SUBMITTAL TO THE BOARD OF SUPERVISORS
COUNTY OF RIVERSIDE, STATE OF CALIFORNIA

SUBJECT: Goetz Road and Newport Road Completion of Improvements including the construction of a new bridge over Salt Creek in the Cities of Menifee and Canyon Lake.

Project No. B8-0643

GOETZ ROAD & NEWPORT ROAD COMPLETION PLANS

Goetz Rd Sewer & Water Improvement Plans
Newport Rd 6" & 12" Recycled Water Improvement Plans

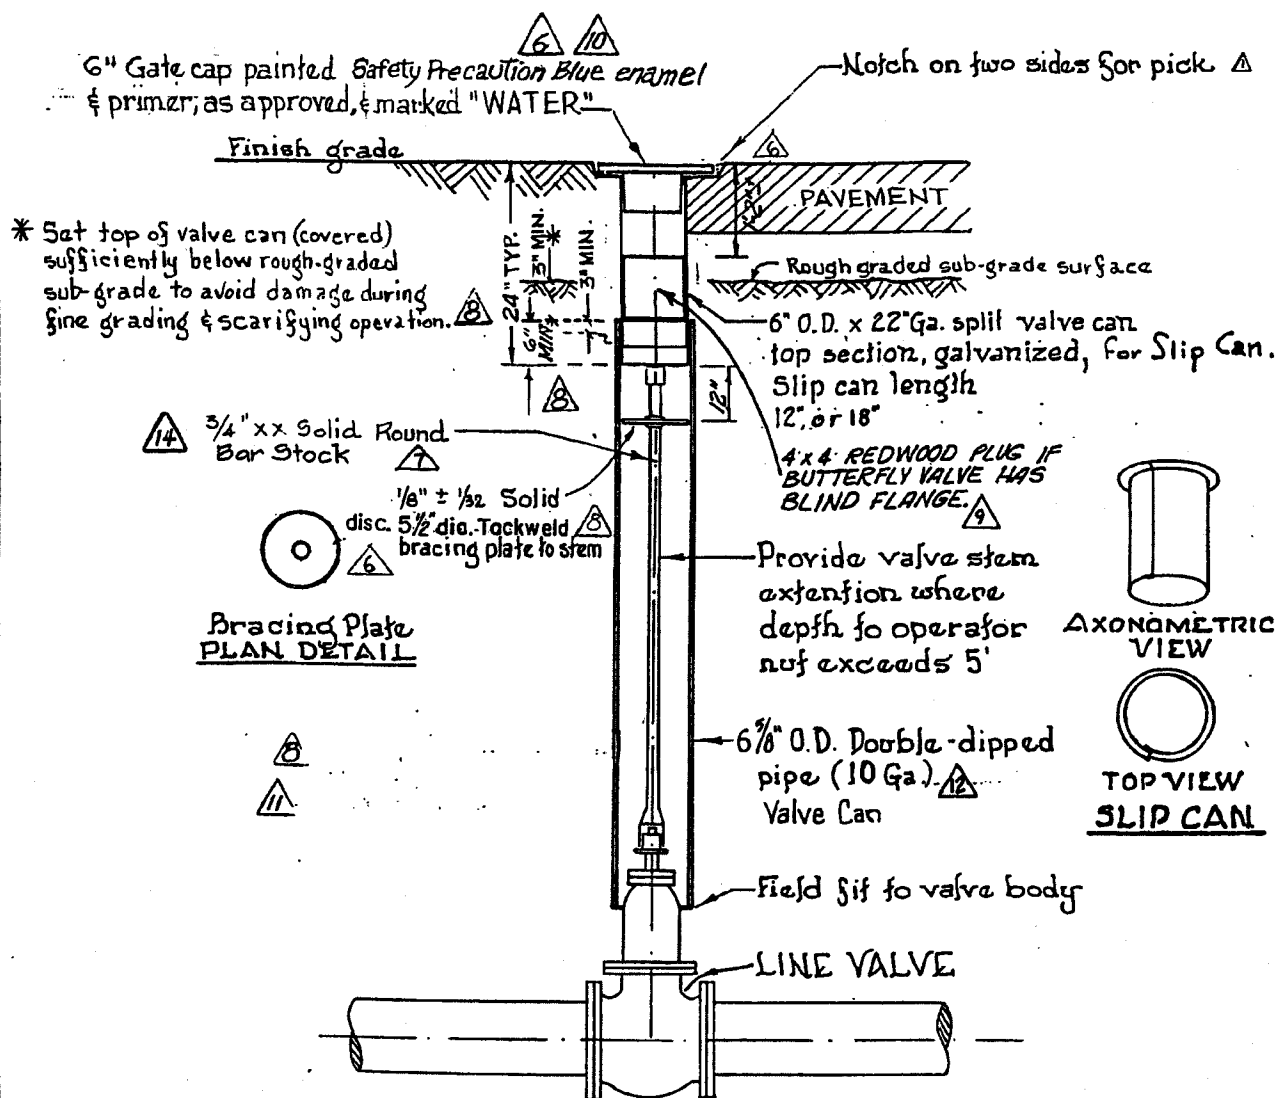
Refer to Riverside County plans

~~D-34066 thru D-34068~~
~~D-34840 thru D-34841~~

BROOKS TRAFFIC BOX
4-TT Series

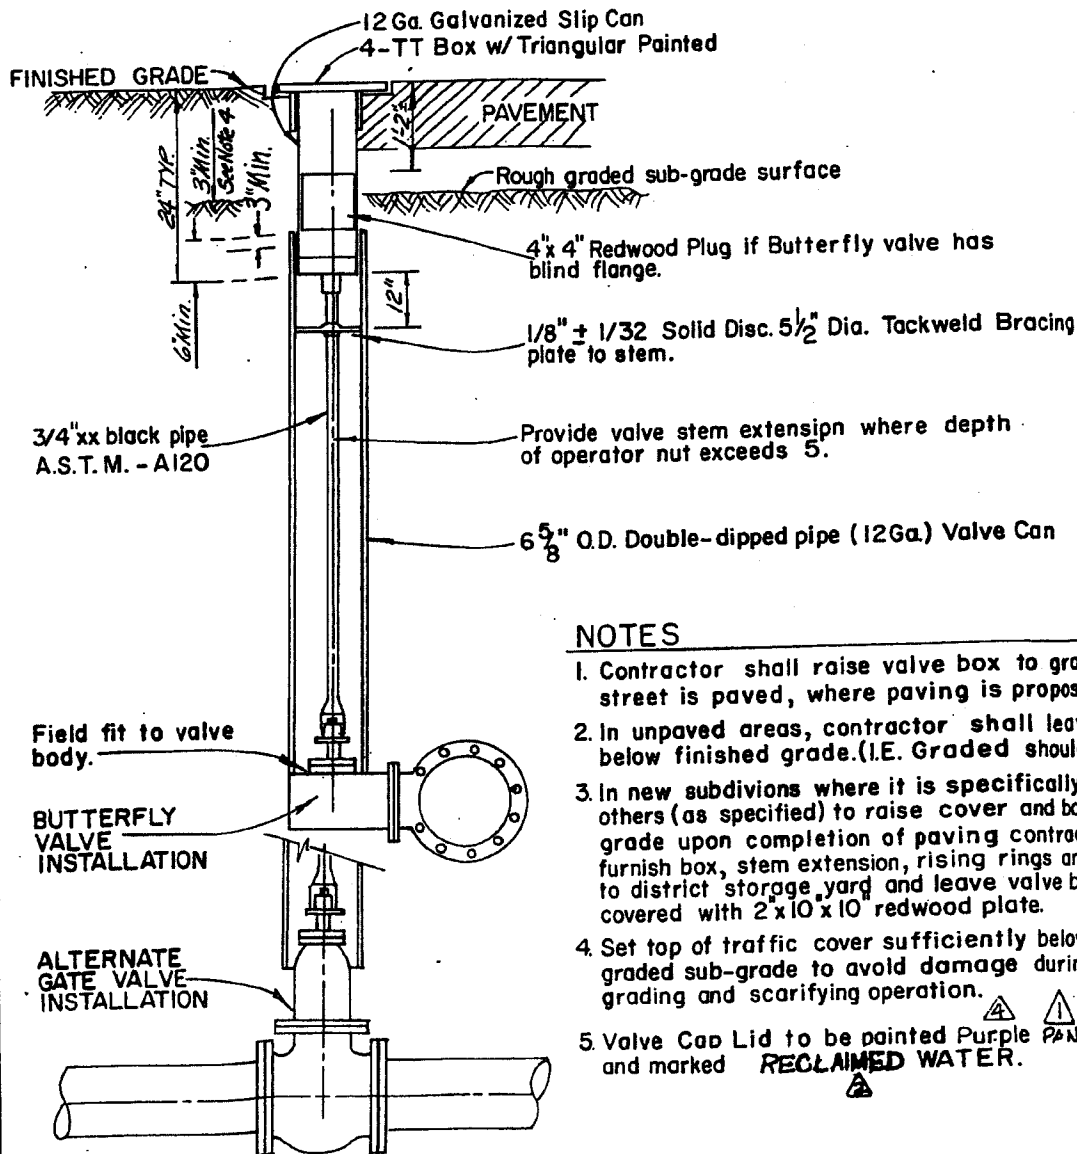
⚠ Plastic riser not allowed, Delete Note 6. *VB 10/17/05*
